RE: PI#(s): 110610- & 0013545, Gwinnett, Barrow, Jackson Counties, I-85 from I-985 to North of SR 53

# ENVIRONMENTAL REEVALUATION

**Project NH-IMO-0085-02(165) &  
NH-IMO-0085-02(166)  
Gwinnett, Barrow, Jackson Counties  
P.I. Nos. 110610- & 0013545**

**I-85 Widening from I-985 to North of SR 53**

**Figure 1 - Project Change Map**  
 I-85 Widening and Improvements  
 P.I.# 110610- & 0013545  
 Gwinnett, Barrow, and Jackson Counties, GA

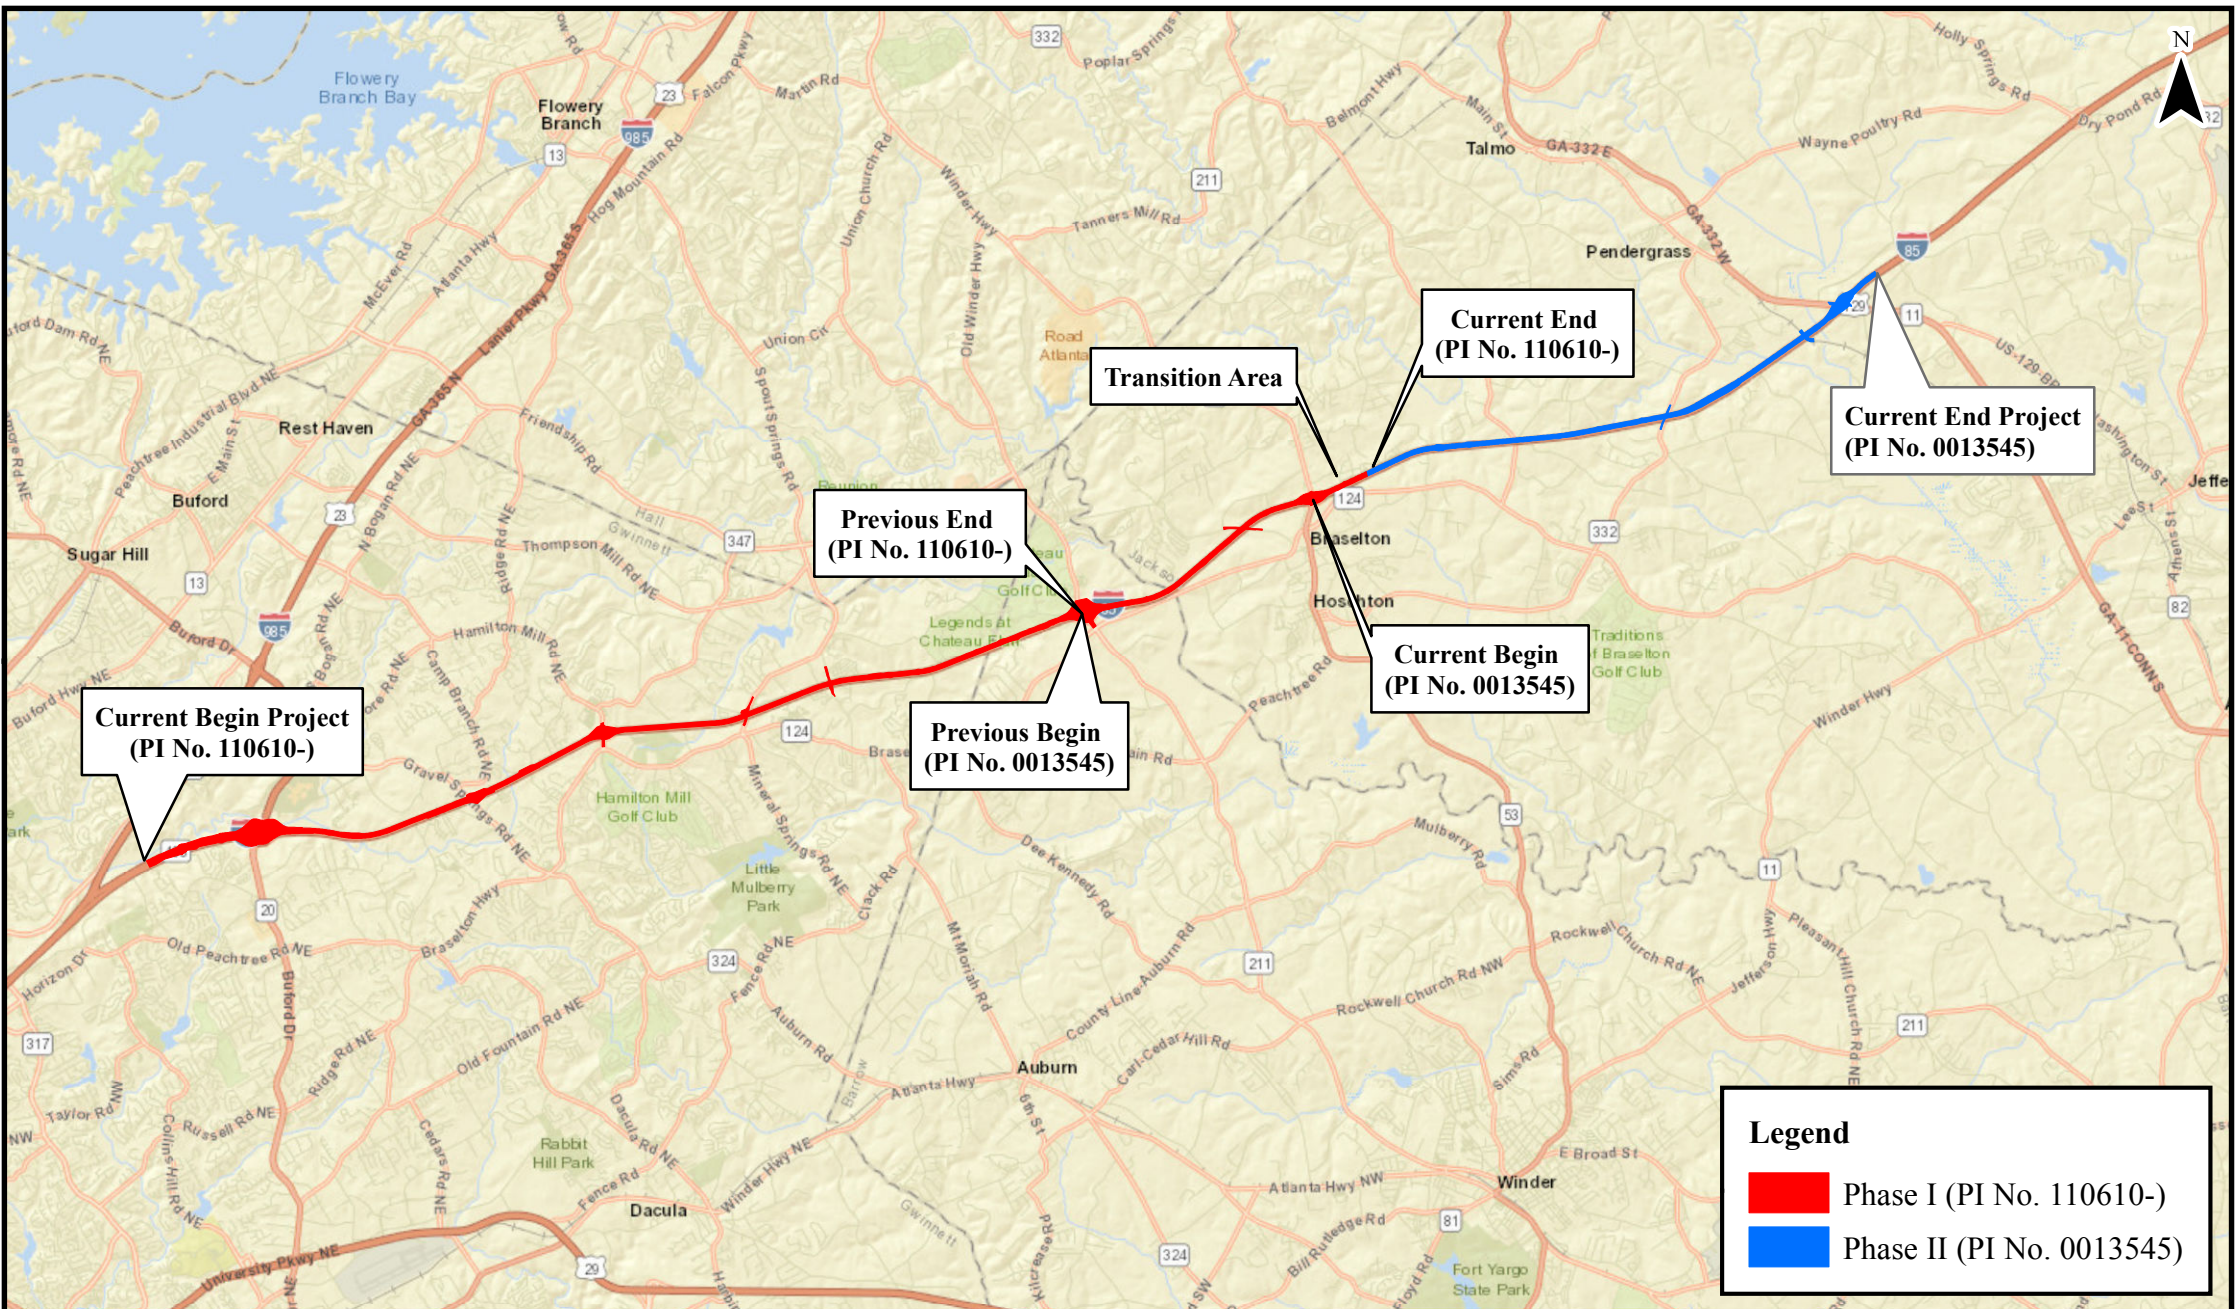
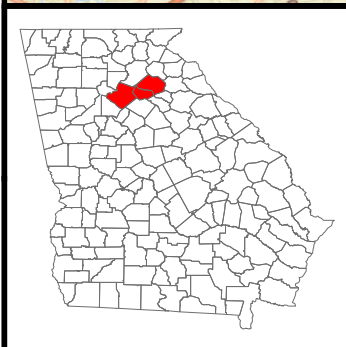
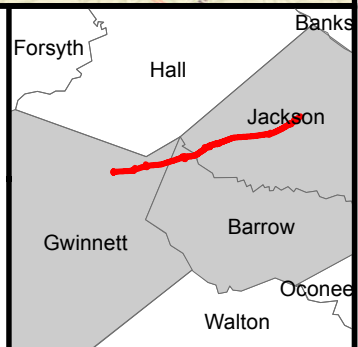
- 1. Comment 2 - The GDOT response to this comment states that the approximately 5.9 miles of general purpose lane striping was included in the Reevaluation Memo for 110600 that was previously approved by FHWA. If the striping of the general purpose lane is being done under 110600, then this area (between SR 20 and Hamilton Mill Road) should no longer be included in the project description and project figures for 110610. Please make changes to the project description and figures as needed.*

Response: The project limits and supporting figures as described in the approved NEPA document for P.I. 110610-/0013545 are accurate for Phase 1 construction limits for the P.I. No. 110610- NEPA Reevaluation document. Coordination of the scopes of work between P.I. Nos. 110600- and 110610- to construct a third lane under 110600- between I-985 and Hamilton Mill Road prior to notice to proceed for P.I. No. 110610- allowed for an efficient use of federal funds resulting from striping activities of the third general purpose lanes under P.I. No. 110600- that would have been conducted under P.I. No. 110610-. This will benefit the public by allowing a shorter construction period for the completion of project 110610-.

Although the Contractor's scope of work for P.I. No. 110610- includes the physical construction of a new, third general purpose lanes as cleared in the NEPA documentation under project P.I. No. 110610- beginning at Hamilton Mill Road, there are additional required project elements that would be completed under P.I. No. 110610- between Hamilton Mill Road and I-985, including the removal and installation of new signage and

removal of the temporary tapering and OGFC paving and striping at Hamilton Mill Road between the Managed Lanes to the west and the new, third general purpose lanes to the east. The tapering would remain in place until completion of the third general purpose lanes under P.I. No. 110610-.

Finally, an Atlanta Regional Commission FY 2018-2023 TIP Modification was approved in September 2018 that describes the project limits for P.I. No. 110610- between I-985 and SR 53. This TIP Modification addresses previous FHWA comments to the CE Reevaluation relating to clarification of project limits.

The NEPA documentation for both P.I. Nos. 110600- and 110610- remains valid and the construction limits and project limits described therein are recommended to be unchanged.

**Figure 6 - Noise Barrier 4**

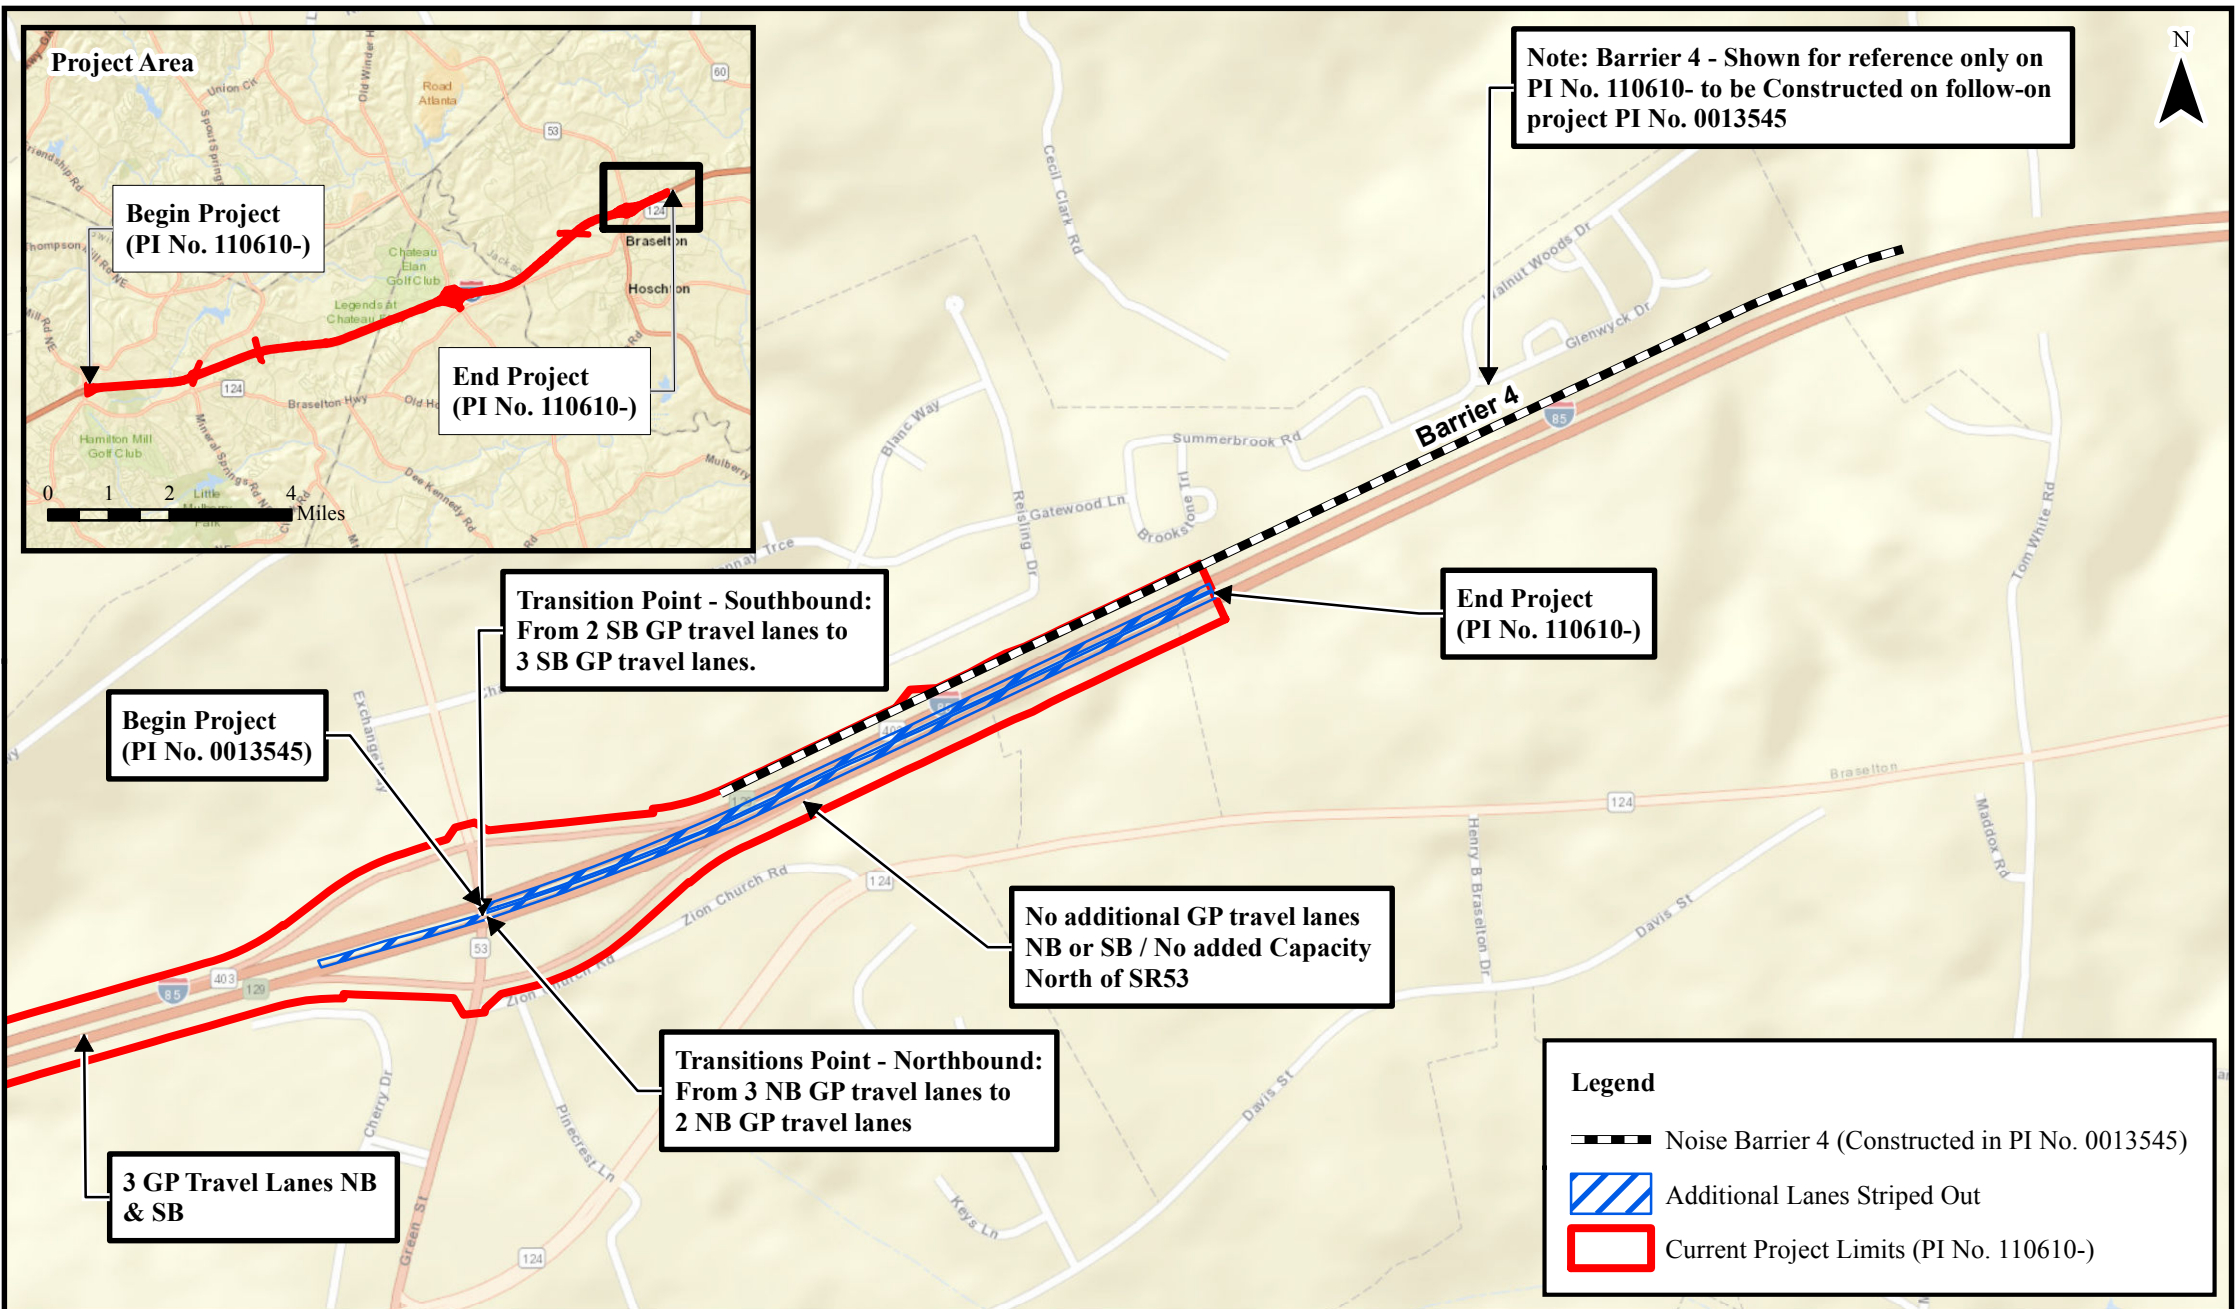
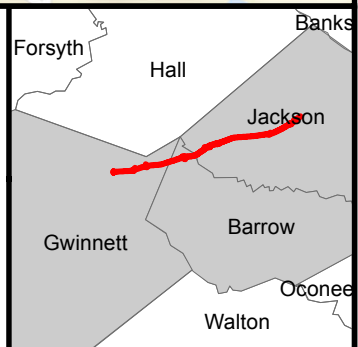
2. *Comment 4 - Please add a commitment to the project Green Sheet which states that public involvement would be conducted with the community in the vicinity of Noise Barrier 4 (as shown in Figure 6 of the reevaluation). The Green Sheet commitment should also state that this public involvement would be done before any construction activities take place north of SR 53. In addition, please include a summary of the purpose of this additional coordination in Attachment 2 of the reevaluation.*

Response: Commitment E-7 has been added to the Green Sheet stating that public outreach would occur within the residential community adjacent to Noise Barrier 4 as shown on Figure 6 of the reevaluation. This outreach will be completed prior to beginning construction activities north of SR 53. A description of the purpose of this outreach has been added to Attachment 2 of the reevaluation on page 10 of 12.
